# Metro Outer Joint Development Assessment Panel Agenda

**Meeting Date and Time:** Tuesday, 15 November 2022; 9:30am  
**Meeting Number:** MOJDAP/209  
**Meeting Venue:** Electronic Means

## ALEXANDRIA VIEW, 50 (LOT 418) MINDARIE – MULTIPLE DWELLINGS (88 UNITS)

### Form 1 – Responsible Authority Report (Regulation 12)

Figure 1: Excerpt of lower ground floor plan (Attachment 1) indicating street setback alignment with 64 Alexandria View

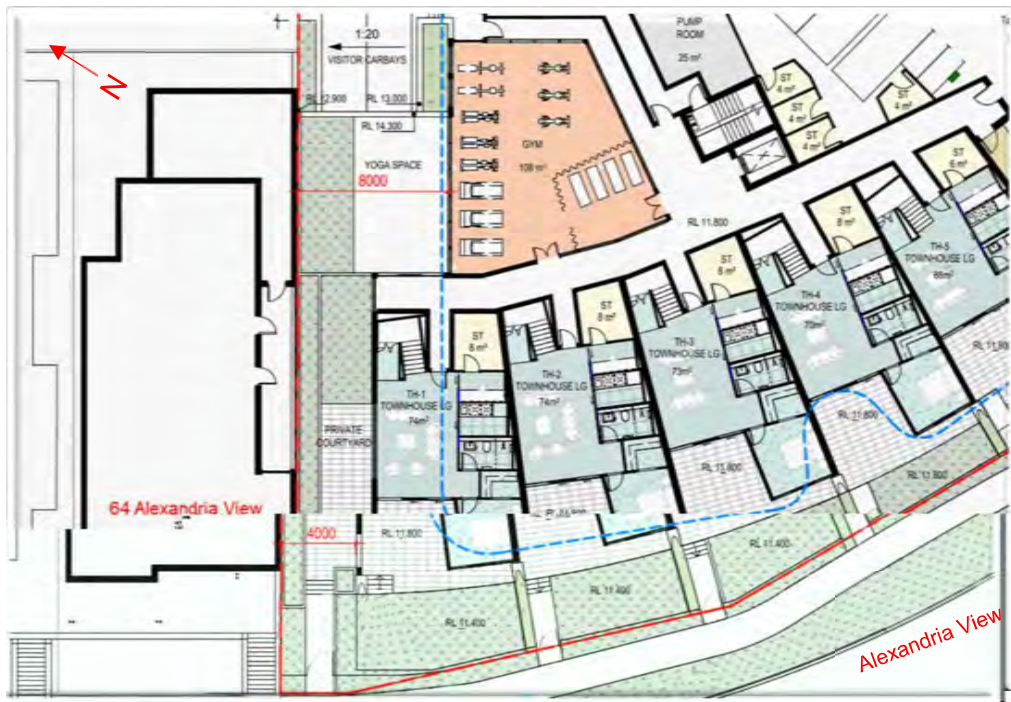
The application does not satisfy DAP 5 as the building is proposed with a reduced setback to Alexandria View as outlined in the above table. A number of submissions also raised concerns in relation to the non-compliance with the street setbacks which will impact on the established streetscape character of Alexandria View.

- a) The proposed street setback, in particular to the south-west side, is generally consistent and aligns with the existing setback of the adjoining property at No. 64 Alexandria View, Mindarie as shown in **Figure 1** below. The proposed street setback of the building will not erode the current streetscape character of the area.
- b) The proposal will still maximise activation to the street with courtyards and balconies facing Alexandria View, providing passive surveillance but also ensuring enough privacy is achieved through landscaping.
- c) There is a clear transition between the private and public domain through the use of fencing, landscaping and steps/level differences.
- d) The design of the building incorporates vertical recesses through a curved design and other measures that provide articulation to the street.

Given the above, the proposal is considered to satisfy the Element Objectives of SPP 7.3 Vol 2, Element 2.3: Street Setback, and is therefore supported.
